Work Order ID 94681

Item Name: Crosstube Aft

DART AEROSPACE LTD		Work Order:	94681
Description: Crosstube High Aft (205/212)		Part Number:	D212-664-201
Inspection Dwg: D212-664-241 Rev: D		Page 1 of 1

DRAWING NO. D212-664-241	TITLE CROSSTUBE ASSY (205/212 HI AFT)	REV. D	DART AEROSPACE LTD ENGINEERING ORDER		D.E.O. NO. D212-664-241-D-1	SHEET NO. SHEET 1 OF 2	SCALE NTS
DRAWN	CHECKED	MFG. APPR.	APPROVED	DE APPR.			
DATE 11.04.07	DATE 11.04.11	DATE 11.04.12	DATE 11/04/12	DATE 11.04.12

FIGURE 1: SUPPORT INSTALLATION

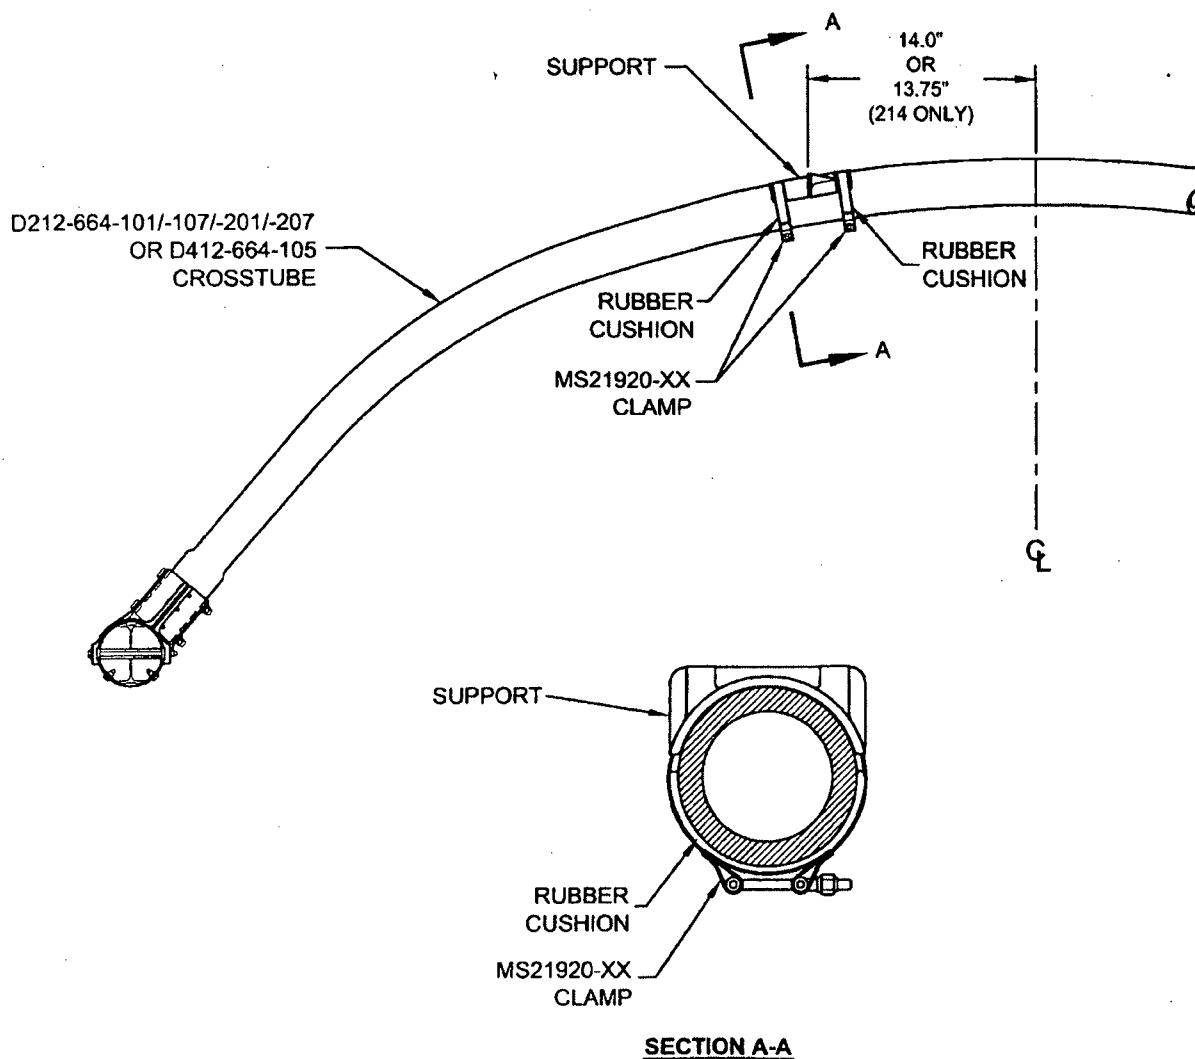
The supports on the following crosstubes are now installed using Proseal instead of Magnobond:

For the crosstubes listed above, section 32.4 of ICA-D212-664 is amended as follows. Use Figure 1 of this service instruction and Figures 32-2 to 32-9 of ICA-D212-664 for further reference. For crosstubes of an earlier change number, it is recommended that if the supports are removed, the supports should be reinstalled using the procedure listed below.

- 32.4.1 Locate the area on the crosstube for installation of support (see Figure 1 of this service instruction). For D212-664-101/-107/-201/-207 and D412-664-105 crosstubes, the outward face of the support tabs should be 14.0" (355mm) from the crosstube center for 204/205/210/412/UH-1 aircraft. For installation on 214B/B-1 aircraft, the outward face of the support tabs should be 13.75" (349mm). Ensure paint finish of crosstube is intact; touch up as required per Chapter 5 (5.3.9) of ICA-D212-664.

- 32.4.2 If present, remove any paint/primer on bottom of supports. Abrade mating surfaces of support and crosstube with 400-grit sandpaper. Saturate a clean cloth with MEK or 4105S Wash'n'Wipe Degreaser or equivalent and wipe until there is no residue.

- 32.4.3 Ensure a layer of 3M Scotch-Weld 2216 B/A Epoxy Adhesive is on the bottom of the support. If required, either apply or touch-up support to have a 0.03" to 0.05" thick layer of adhesive over the entire mating surface. Allow supports to cure for 24 hours.

- 32.4.4 Abrade mating surfaces of support (after cure) and crosstube with 180-grit sandpaper. Saturate a clean cloth with MEK or 4105S Wash'n'Wipe Degreaser or equivalent and wipe until there is no residue.

- 32.4.5 Apply a 0.04" to 0.07" thick layer of Proseal 890 Class B or AMS-S-8802 Class B sealant underneath applicable support and install support as shown in Figure 1 of this service instruction.

- 32.4.6 Install the clamps opposite to crosstube support as shown in section A-A of Figure 1. Install rubber cushions underneath each clamp around the bottom circumference of the crosstube up to the crosstube centerline. Torque clamps 80-100 in·lb (9.0-11.3 Nm). It is acceptable to use smaller or larger sized MS21920-XX clamps than those listed in ICA-D212-664, ensure that after torquing the clamps per this instruction, the nuts are in safety but not bottomed out

- 32.4.7 Prior to installing crosstube on aircraft, allow supports to cure for 72 hours and recheck torque on clamps.

**D212-664-241/-241B
ASSEMBLY DETAIL**

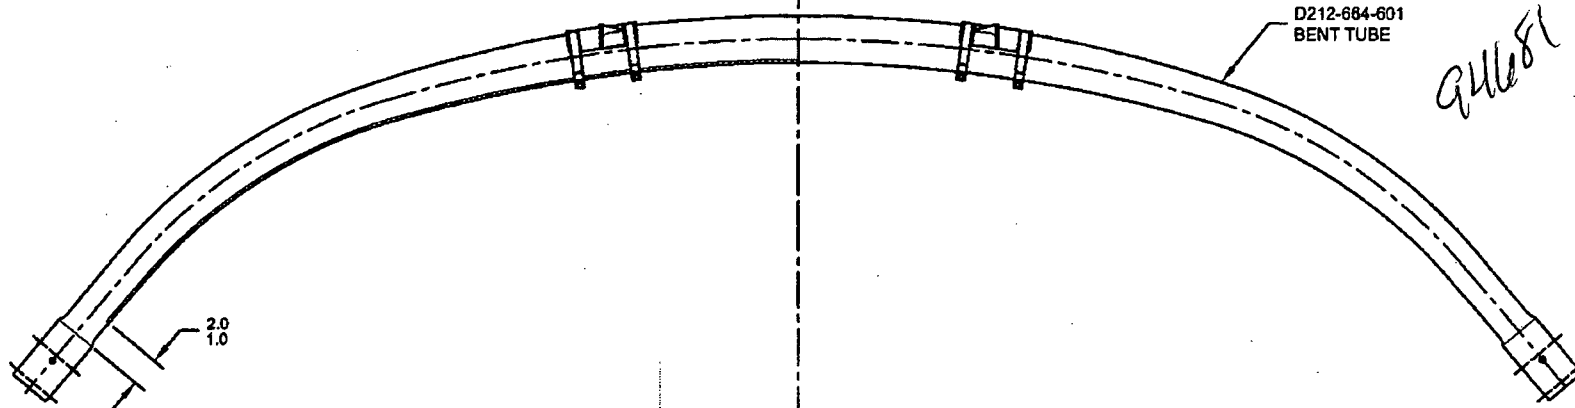
ADD AN INSPECTION WINDOW TO UNDERSIDE OF CROSSTUBE.

NOTES 2 OF SHEET 1 IS AMENDED AS FOLLOWS:

- 2) FINISH: CHEMICAL CONVERSION COAT PER DART QSI 005 4.1
PRIME INSIDE AND OUTSIDE PER DART QSI 005 4.2
MASK UNDERSIDE OF CROSSTUBE AS SHOWN (HATCHED AREA) AND
PAINT OUTSIDE PER DART QSI 005 4.2
REMOVE MASKING AND APPLY CLEAR COAT

MASK AREA PRIOR TO PAINTING,
REMOVE MASKING AFTER PAINT
AND APPLY CLEAR COAT

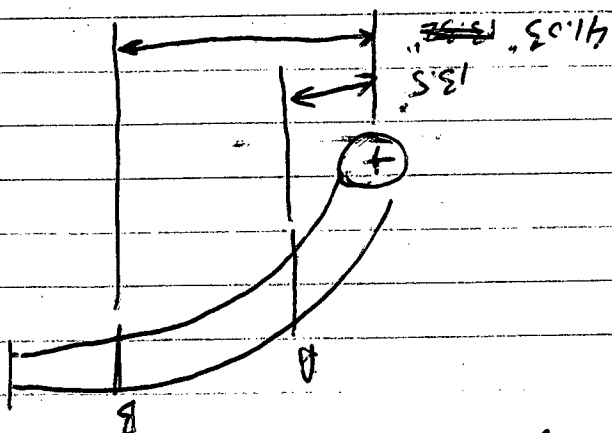
REPLACE MAGNOBOND WITH PROSEAL.

NOTE 12 & 15, SHEET 1 IS AMENDED AS FOLLOWS:

Item	Qty -241	Qty -241B	Part Number	Description
7	A/R	A/R	PROSEAL 890 B-2	SEALANT, AMS-S-8802 CLASS B-2

- 12) TO INSTALL D2940-1 SUPPORT: ABRASE MATING SURFACE OF SUPPORT AND CROSSTUBE WITH 180-GRIT SANDPAPER AND REMOVE RESIDUE WITH MEK (OR EQUIVALENT). APPLY A 0.04" TO 0.07" THICK LAYER OF PROSEAL 890 CLASS B-2 (OR AMS-S-8802 CLASS B-2) SEALANT TO MATING SURFACE OF SUPPORT.
- 15) TORQUE CLAMPS 80 TO 100 IN-LB. ENSURE AT LEAST 1.5 THREADS SHOWING IN SAFETY AND THAT NUT HAS NOT BOTTOMED-OUT AFTER TORQUING. **PRIOR TO PACKAGING, RE-CHECK TORQUE ON CLAMPS AFTER PROSEAL 890 SEALANT HAS CURED FOR 72 HOURS.**
